**Texas Parks and Wildlife Department
4200 Smith School Road
Austin, Texas 78744**

ADDENDUM

Addendum Number:	<u>04</u>	Dated:	<u>September 3, 2015</u>
Solicitation Number:	<u>IFB No. 802-15-31712</u>		
Solicitation Title:	<u>Post and Cable Fence Installation at Mustang Island SP</u>		
Revised Due			
Date/Deadline:	<u>September 10, 2015</u>		
Purchaser:	<u>Dominik Mendoza, CTPM, CTCM</u>

PURPOSE OF ADDENDUM: OFFICIAL REVISIONS AND QUESTIONS AND ANSWERS

ATTACHMENT C – RIGHT OF WAY

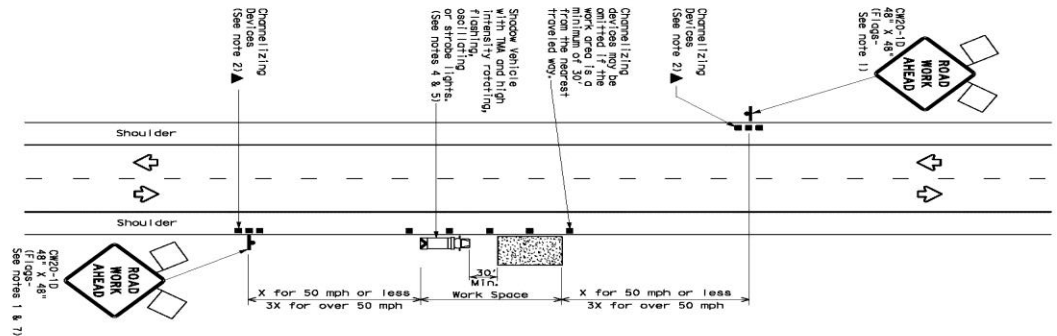
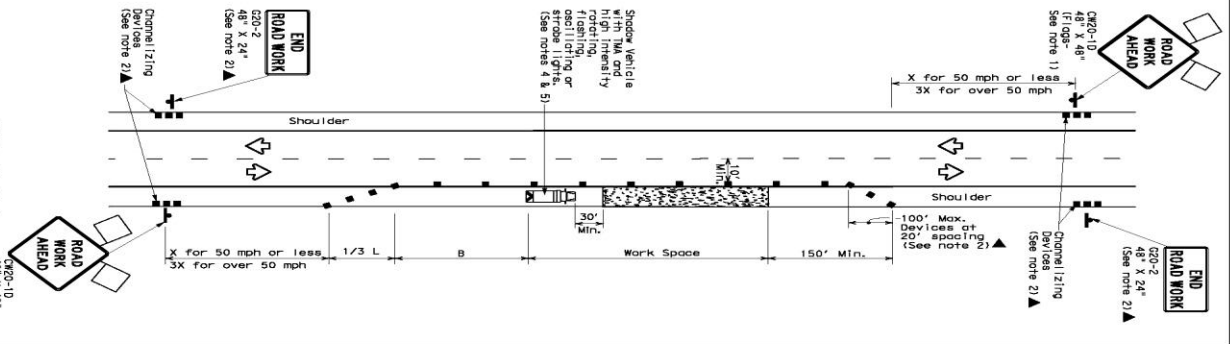
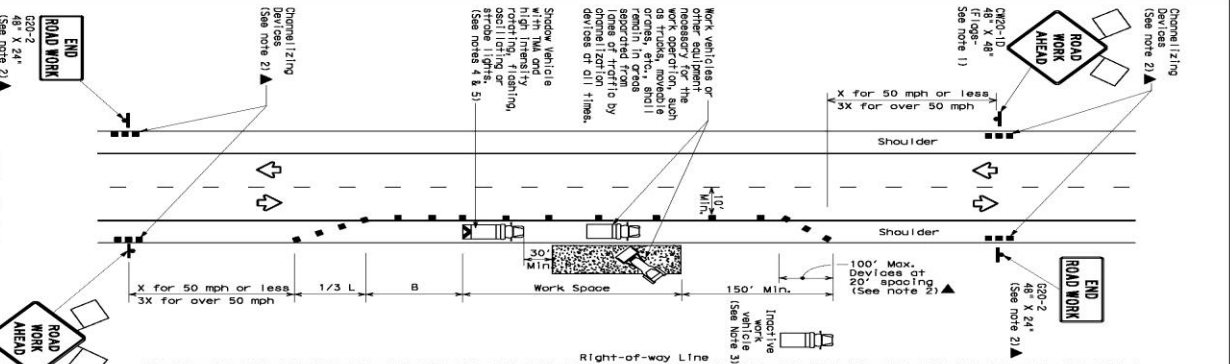
Attachment C, hereby becomes part of the subject specifications:

Question: Can we shred on the right of way (ROW)? If yes, can we mow 12' inside existing fence?

Question: I need some clarification on your spec for the pull post. On the spec sheet everything is converging at the same point of the post but how are they tied together.

Response: Shredding or mowing of the TXDOT ROW is allowed and contractor must adhere to all TXDOT regulations for operating within the ROW, [Attachment C, Right of Way](#). Contractor's may shred/mow 12' inside the fence utilizing a track skid steer with mower attachment or a tractor with wheels, no other equipment with wheels is allowed. If a Contractor utilizes a tractor to shred/mow, the equipment is only allowed to operate from the road to the end of the fence. Contractor may shred/mow one (1) six (6) foot wide path each way and will not be allowed to remain on site or used to conduct the fence construction.

Response: Drawing details, [Attachment C – Right of Way](#), verify there is no tie in at the pull post. The cable passes through the post to the anchor on the opposite side of the post; this is true whether it is an end pull post or inline pull post. The inline pull post will have 2 cables passing through to the anchors on the opposite sides of the post.

Example: Cable coming from the north will pass through the post to the anchor on the south side and vice-versa.
